**Re: Development Application, 166-176 St Andrews Road, Varroville – File No. 3293/2017/DA-C**

This submission is made on behalf of the Scenic Hills Association Inc. regarding the above Catholic Metropolitan Cemeteries Trust (CMCT) Development Application (DA) - **File No. 3293/2017/DA-C**. We ask that the DA be rejected on the following grounds:

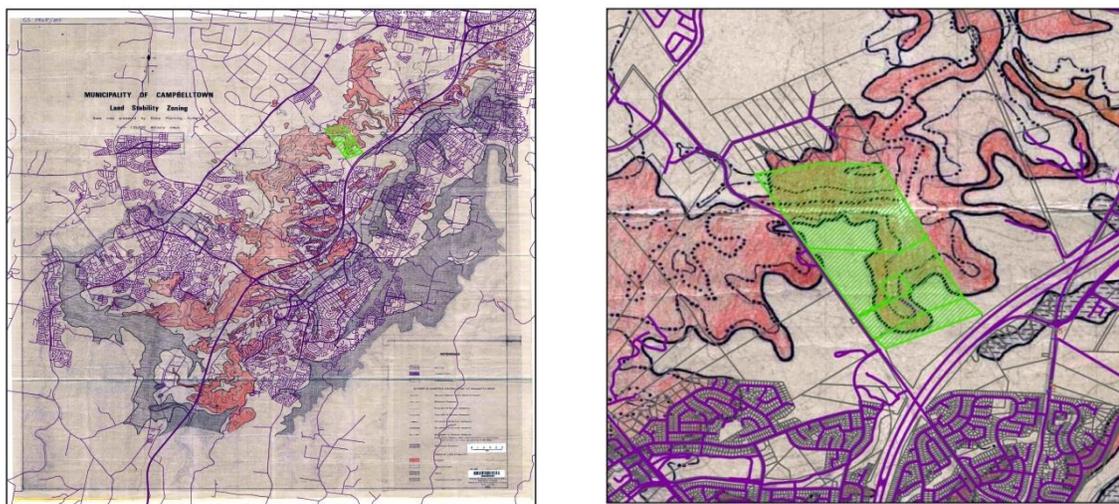
heritage curtilage. See photo below by landscape heritage consultant Geoffrey Britton. Dense tree plantings, only partly hiding the cemetery development, will remove the long viewlines, while 8m concrete roads (with kerb parking) will separate the Homestead from its outbuildings and from the vineyard terracing. A burial room with above ground headstones is to be located hard up against the Homestead's rear boundary, and the historic driveway from St Andrews Road to the outbuildings will be destroyed.
